Subject: Repair/Replacement of Missing or Altered Storefronts

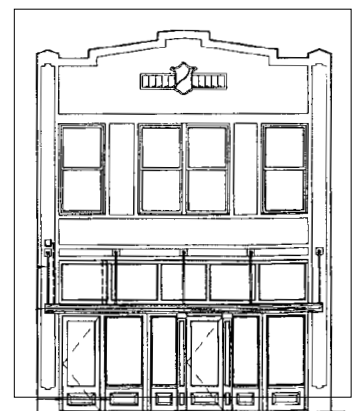
**Application 3** (*Incompatible treatment later modified to meet the Standards*): This small, two-story brick building, originally constructed in 1889 as a newspaper office, had been “modernized” with an aluminum storefront installed in the 1950s. Although no historic photographs were found to show the building's original appearance, the storefront still had two entrances, one on the left leading to the upstairs, and another leading to the newspaper offices on the first floor. As part of a recent project to rehabilitate the building as a sports bar with apartments upstairs, a new, varnished wood storefront had been installed along with a very large awning that concealed the still extant, historic transom above the storefront. This new storefront was incompatible in scale, proportion, color and finish with the character of the historic building.

The storefront of this 1889 building was altered in the 1950s (left). The replacement storefront and awning were incompatible in scale, proportion, color and finish with the historic building (center). Remedial work to make the new storefront compatible will include re-installing a horizontal metal awning, painting the wood, and increasing the glass to wood ratio of the storefront (right).

Remedial work was proposed to bring the storefront into compliance with the Standards. The proportions of the storefront were corrected by lowering the height of the bulkhead panels and lengthening the glass in the display windows and the entrance doors. A traditional metal horizontal awning suspended from the facade would be installed which would once again reveal the transom. And, the new varnished wood of the storefront—the varnish already deteriorating rapidly on this west exposure, would be given a traditional painted finish, more appropriate to the character of the historic building and more protective of the wood.
